# Proposed Revisions to a Standard Plans Index

Index Number: 350-001 Sheet Number (s): 1 of 4 Index Title: Concrete Pavement Joints

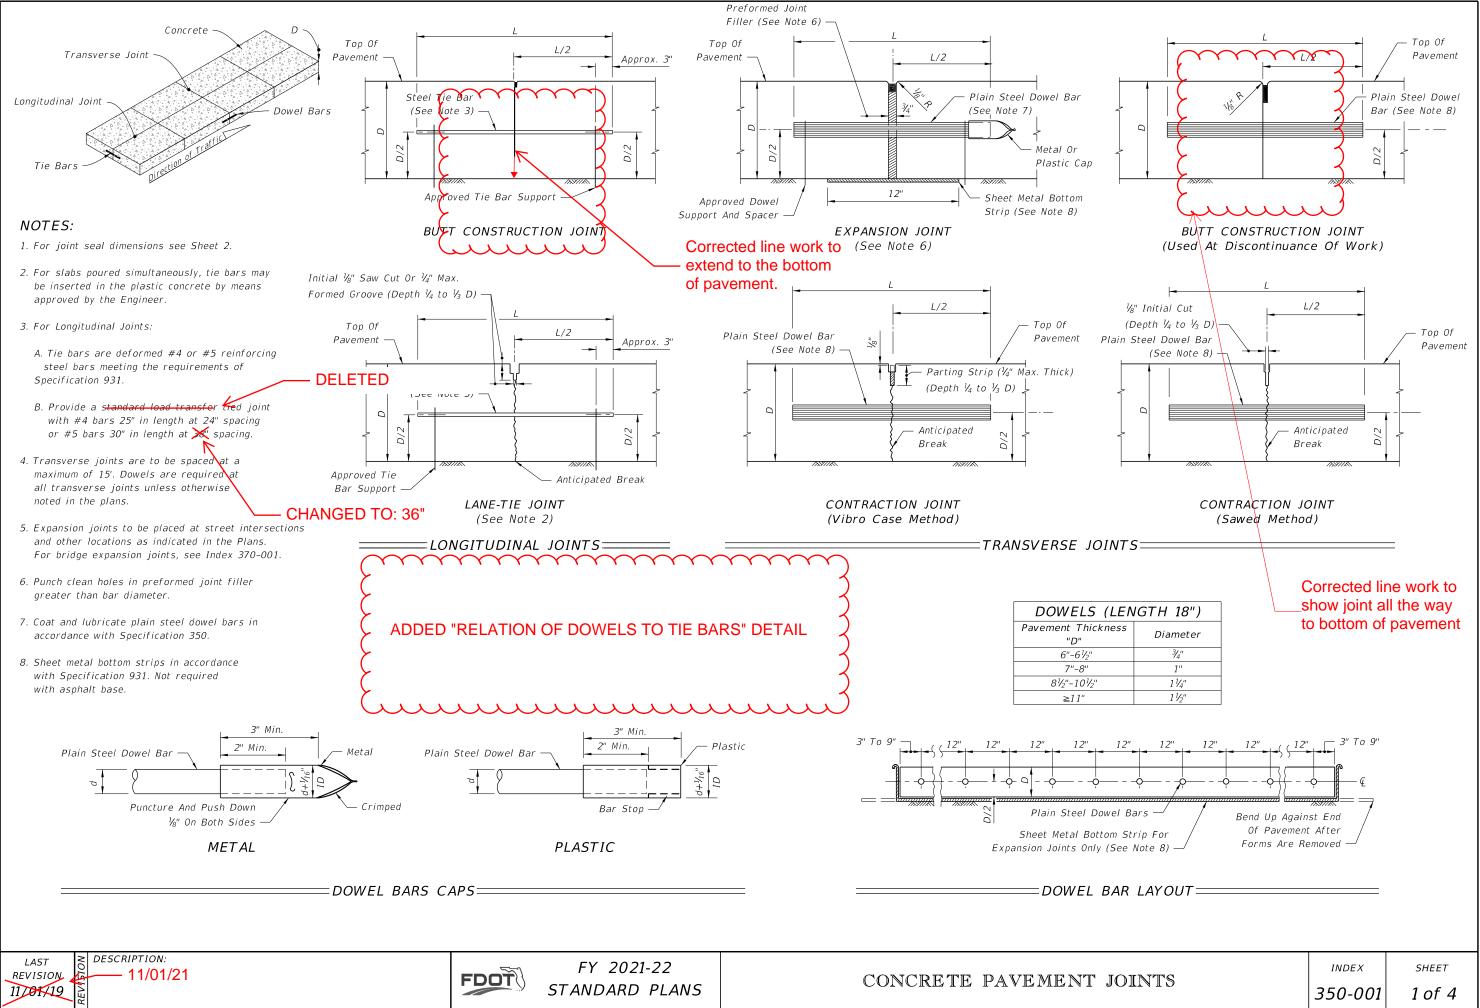
Sheet 1: Updated Note 3.B (Deleted "standard load transfer" and changed Spacing of #5 bars from 38"); Correct line work to extend to the bottom of the pavement in the BUTT CONSTRUCTION JOINT details; Added "Relation of Dowels to Tie Bars" detail.

Rev 1: Clarification-Butt Construction Joints should be depicted to show the joint extending from the top of the slab all the way to the bottom of the slab. Rev 2: Correction-tie bars are not used for load transfer. Rev 3: Change-tie bar spacing changed to provide a consistent and even spacing for slabs, which are typically 15' long. Rev 4: new detail.
